Access Compliance Report

Public Rights-of-Way

Intersection ID: 10033270	Main Street: OAKDALE_GREEN_DR	Cross Street: N/A	Location: SE
ADA ID: 7579E4FF7F00	Ramp Type: BlendTrans1	Initial Pass/Fail: Pass	Overall Compliance: No
		Severity Score: 0.25	
Codes/Mitigation Info/Possible Solution		Field Measurements/Component Compliance

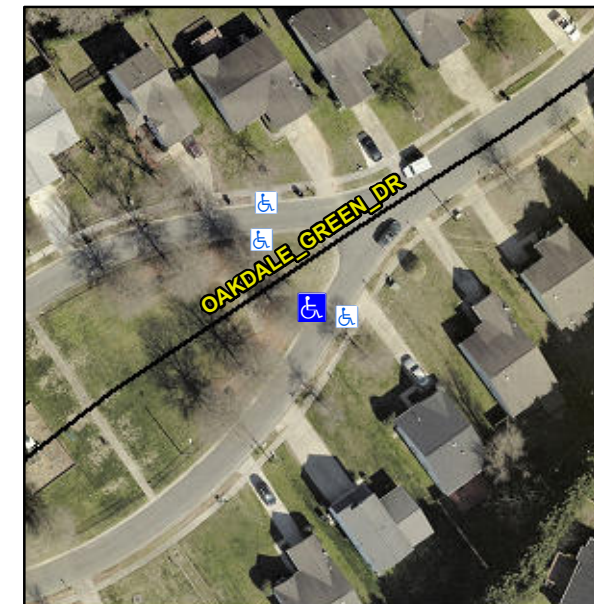
Not Found, R304.5.3, R305.2

Compliance	Description	Data	Compliance	Description	Data
N/A	Ramp Length (in)	66.0	Yes	BlendTrans Slope (%)	3.6
Yes	Ramp Width (in)	61.0	No	BlendTrans XSlope (%)	2.2
N/A	Flare Type LT	None	N/A	Flare Type RT	None
N/A	Flare Slope LT (%)	N/A	N/A	Flare Slope RT (%)	N/A
N/A	Flare Traversable LT?	N/A	N/A	Flare Traversable RT?	N/A
Yes	Landing Length (in)	79.0	Yes	DWS Provided?	Yes
Yes	Landing Width (in)	60.0	Yes	DWS Contrast?	Yes
Yes	Landing Slope (%)	0.9	Yes	DWS Length (in)	24.0
No	Landing X Slope (%)	2.7	Yes	DWS Full Width?	Yes
N/A	Landing Curb? (Y/N)	No	No	DWS Offset (in)	4.5
N/A	Shared Landing?	No			
Yes	Gutter Ponding?	No	Yes	Gutter Slope (%)	4.5
Yes	Gutter Lip Ht (in)	0.0	Yes	Gutter X Slope (%)	1.3
N/A	Painted X Walk1?	No	N/A	Painted X Walk2?	N/A
	X Walk 1 Direction	To SE		X Walk 2 Direction	N/A
	X Walk 1 Width (in)	N/A		X Walk 2 Width (in)	N/A
	X Walk 1 Slope (%)	0.5		X Walk 2 Slope (%)	N/A
	X Walk 1 X Slope (%)	1.8		X Walk 2 X Slope (%)	N/A

N/A	Ramp inside XWalk1?	N/A	N/A	Ramp inside XWalk2?	N/A
	Road Slope (%)	1.8		Clear Space?	Yes
	Road X Slope (%)	0.5	N/A	Clear Space to XWalk (in)	N/A
Yes	Any Obstructions?	No	Yes	Storm Grate/Utility Hazard?	No
	Obstruction Type			Storm Grate/Utility Type	
			N/A		N/A
			Yes	Surface Condition? (G/P)	Good
			No	Curb Slope (%)	16.6

Remove & Replace Curb Ramp With Two New Directional Ramps or Equivalent.
